# CITY PLANNING COMMISSION

**APPLICATION:** Special Permit to allow a 2,732+ sq. ft. church addition on 0.5+ developed acres in the Standard Single Family (R-1) zone.

**LOCATION:** 4800 Martin Luther King Boulevard

# EXHIBIT A SITE PLAN

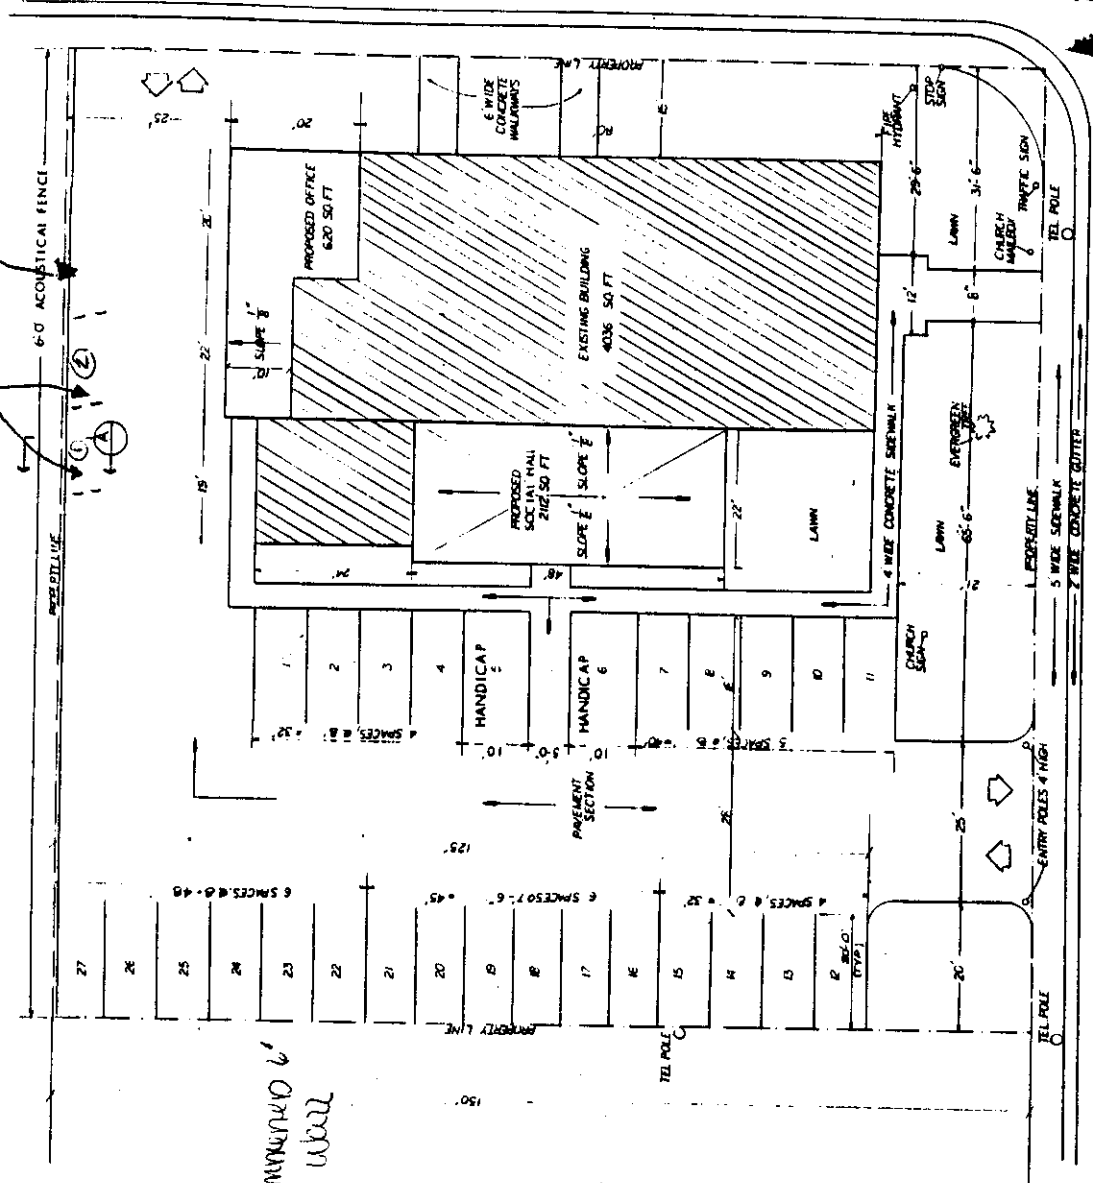
A minimum six foot masonry wall is required, if a church abuts a residential use or zone. Staff observes a leaning cyclone fence between the church site and residential use along the west property line. Staff recommends that a six foot masonry wall be placed on the west and south property lines to screen and allow for a visual buffer between the two uses. Staff also noticed air conditioning equipment on top of the building. Staff recommends that all mechanical equipment be adequately screened. The screening material shall be reviewed and approved by the Planning Director prior to issuance of building permits.

130. A total of twenty-two (22) parking spaces are, therefore, required. Parallel parking is not allowed, therefore, staff recommends that the two existing parallel spaces be removed.

parallel parking  
Recommended 6' wall

Recommended 6' wall

1. A six foot masonry wall shall be placed on the west and south property lines prior to issuance of a building permit.
2. All mechanical equipment on the roof shall be adequately screened. The screening material shall be reviewed and approved by the Planning Director prior to issuance of building permits.
3. The two parallel parking spaces located on the west property line shall be removed.
4. The applicant shall repair or replace any substandard improvements to the satisfaction of the City Traffic Engineer.
